QUALITY ASSURANCE -- NON-CONFORMANCE REPORT

Report No: NCR-000493

Reference Description: Repair of cracks without CWR on Cantilever Bike Path Bracket for Lift 5E

Job Name: SAS Superstructure

Reference Description: Visual Cracks found on fillet welds of Bike Path Cantilever Brackets on 5AE PP29

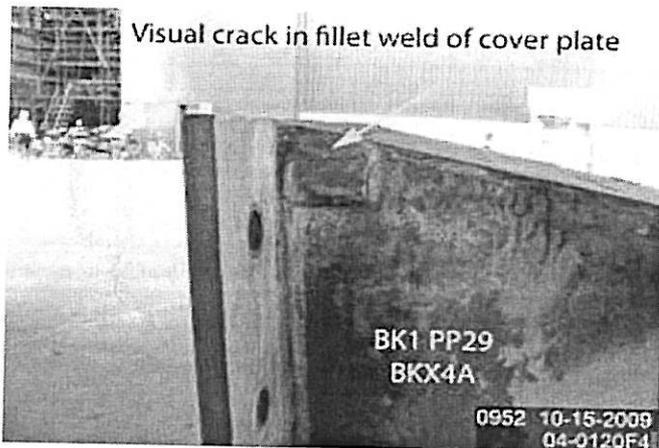
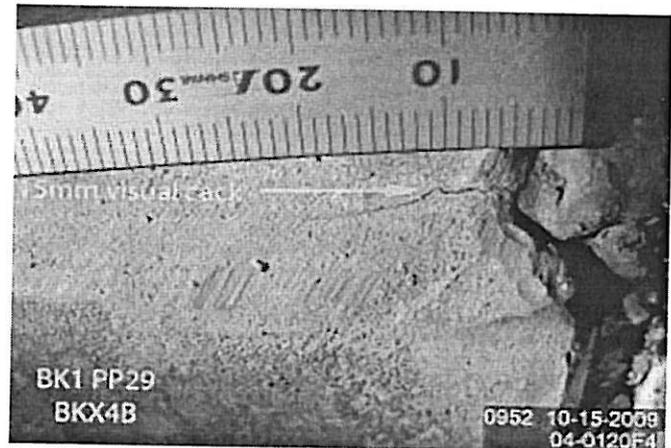
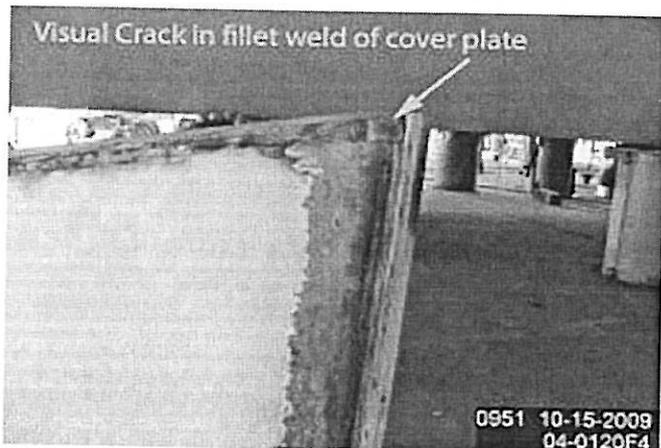
During a random visual inspection of OBG Segment 5AE Bike Path Cantilever Brackets (BK1), Caltrans Quality Assurance (QA) Inspector discovered visual cracks in the fillet welds on the top cope hole cover plates BKX4A and BKX4B at panel point 29. The visual crack observed on BKX4A measured 13mm in length and 15mm in length on BKX4B.

AWS D1.5-2002 Section 6.26.1.1; The weld shall have no cracks.

Reference Description: Repair of cracks without CWR on Cantilever Bike Path Bracket for Lift 5E

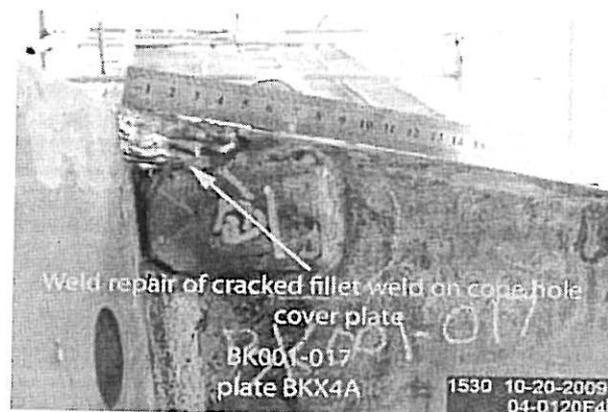
During random visual inspection the Caltrans Quality Assurance (QA) Inspector observed weld repairs were performed on cracks in the fillet welds on the top cope hole cover plates on plates BKX4A and BKX4B of BK001-017. Carbon air arc gouging was used to remove the cracks. NDT was not performed on the excavated area to insure the defect was completely removed. The weld repair was performed with the Flux Cored Arc Welding (FCAW) process. The fillet welds of the cover plate do not have a designated weld numbers for identification. These repairs were performed without an approved welding procedure and the Engineer's approval. These cracks were found on Oct 15, 2009. (see NCR ZPMC-0452)

"The Engineer shall be notified immediately in writing when welding problems, deficiencies, base metal repairs, or any other type of repairs not submitted in the WQCP are discovered and also of the proposed repair procedures to correct them. For requests to perform repairs, the Contractor shall include an engineering evaluation of the proposed repair. The engineering evaluation, at a minimum, shall include what is causing the
